**Validation report form for post-registration changes for
CDM project activities
(Version 03.0)**

Title and UNFCCC reference number of the project activity	Project 9425 : Biogas Recovery and Utilization project in Tay Ninh Province, Vietnam
Process track	<input checked="" type="checkbox"/> Prior approval <input type="checkbox"/> Issuance <input type="checkbox"/> Renewal of crediting period
Version number of the validation report	2.1
Completion date of the validation report	01/10/2021
Type(s) of PRCs	<input type="checkbox"/> Temporary deviations from the registered monitoring plan, applied methodologies, standardized baselines or other methodological regulatory documents ¹ <input type="checkbox"/> Corrections <input type="checkbox"/> Changes to the start date of the crediting period <input type="checkbox"/> Inclusion of a monitoring plan <input checked="" type="checkbox"/> Permanent changes to the registered monitoring plan, or permanent deviation of monitoring from the applied methodologies, standardized baselines or other methodological regulatory documents <input type="checkbox"/> Changes to the project design <input type="checkbox"/> Changes specific to afforestation and refor

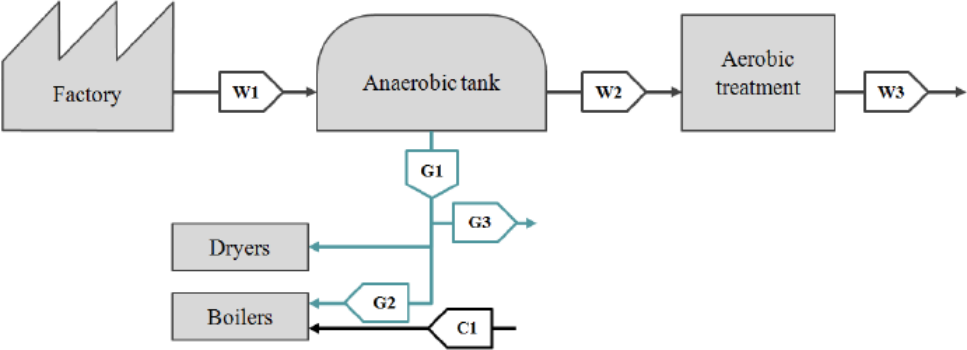
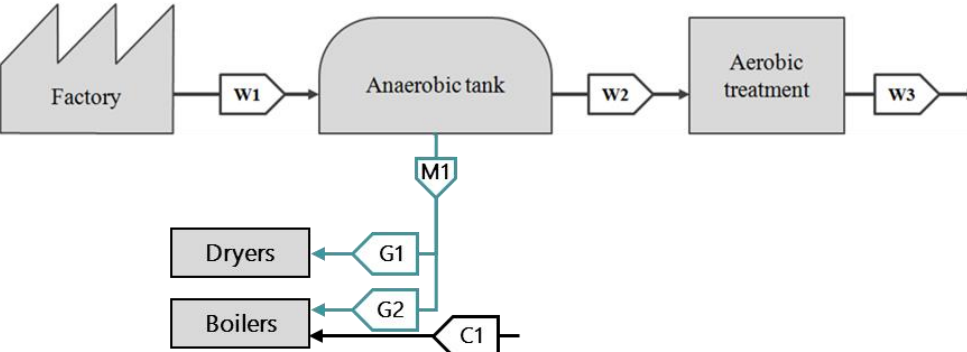
Means of validation	<p>During on-site assessment, validation team inspected actual project implementation status, especially focused on monitoring aspect. Validation team figured out difference between monitoring system in the registered PDD and actual project site. Then, validation team requested PP to revised monitoring plan in the PDD reflecting identified differences.</p>
Findings	<p><u>(1) changes to location of measuring equipments</u></p> <p>In the registered(original) PDD^{/1/}, PP has planned to install biogas vent pipeline for emergency situation, but validation team found that vent line was not actually installed. In this reason, monitoring parameters ($BG_{vent,y}$ and $PE_{vent,y}$) are not needed anymore. Validation team interviewed chief of the factory, then identified that installation of emergency venting line is not mandatory in the host county. As a cross-check manner, validation team reviewed similar registered CDM project^{/10/} in the same host country. The PDD^{/10/} also describes that venting is not mandatory in the host county.</p>  <p style="text-align: center;">Figure 1. Monitoring diagram in the registered PDD</p> <p>As shown above figure 1, PP was planned to install three(3) gas flowmeters at G1, G2, and G3, with gas analyzer at G1. However, vent line has not been installed, so G3 has not been installed. Applied methodology AMS-III.H. (ver.16)^{/3/} paragraph 9 describes that if vent gases are channeled to storage bags, project emissions from venting gases do not have to be considered. So, $PE_{vent,y}$ is not required parameter in the applied methodologies, but defined in the original PDD by reflecting actual project design. In this reason, validation team concluded that this change does not impact on application of methodologies.</p> <p>Moreover, validation team reviewed monitored data^{/8/} of gas flowmeters and found that amount of gas flow at G1 is not accurately measured nor recorded because straight line before & after G1 is not secured enough. So, PP changed location of gas flowmeter of G1 to prior to dryers. Finally, monitoring diagram in the revised PDD was changed as shown below:</p>

<p style="text-align: center;">Figure 2. revised monitoring diagram</p> <p>Total amount of biogas captured by the project activity would be determined as sum of G1 and G2, with methane contents measured at M1. Validation team inspected project site and confirmed type and location of measuring equipments.</p> <p>Besides, equation numbers in original PDD are changed because equation (10) related to $PE_{vent,y}$ was removed.</p> <p><u>(2) changes to calibration frequency</u> Revising of monitoring system, PP also changed calibration frequency for measuring devices reflecting latest version of local regulation. Validation team reviewed applied regulation Decision 23/2013/TTBKHCN^{9/} issued by Ministry of Science and Technology of Viet Nam, and confirmed it.</p> <p><u>(3) Changes to monitoring organization</u> Last major change is organizational structure described in page 50, B.7.3 of original PDD. LIG system, consulting firm, was constructed to carry out monitoring activity and preparing issuance process, but now the company does not provide CDM consulting service anymore. In this reason, PP changed that headquarter of Miwon Vietnam Co., Ltd participated in the monitoring activity. So, organizational structure in B.7.3 of the PDD was changed.</p> <p>CAR 01 was raised and closed at this section.</p>

CAR ID	01	Section no.	D.6	Date: 22/06/2018
Description of CAR				
PDD describes that BG _{burnt} and BG _{boiler} would be measured by gas flowmeters, but actual status not in line with the monitoring plan				
Project participant response				Date: 07/01/2021
PP installed a new gas flowmeter and started collecting data. According to the flowmeter, callibration frequency was corrected as per the Ministry of Science and Technology in Vietnam.				
Documentation provided by project participant				
Revised PDD				
DOE assessment				Date: 13/01/2021
KSA reviewed revised PDD and confirmed description is as checked by VT during on-site assessment

Conclusion	<p>Validation team concluded that permanent changes to the registered monitoring plan:</p> <ul style="list-style-type: none"> (1) still comply with relevant CDM requirements such as CDM PS PA, VVS PA, and applied methodologies. (2) do not reduce the level of accuracy of the monitoring compared with the requirements contained in the registered monitoring plan (3) is not likely to lead to a reduction in the accuracy of the calculation of emission reductions. (4) do not impact on estimated emission reductions because venting line was considered for emergency situation, so $PE_{vent,y}$ would be 0 in most cases.
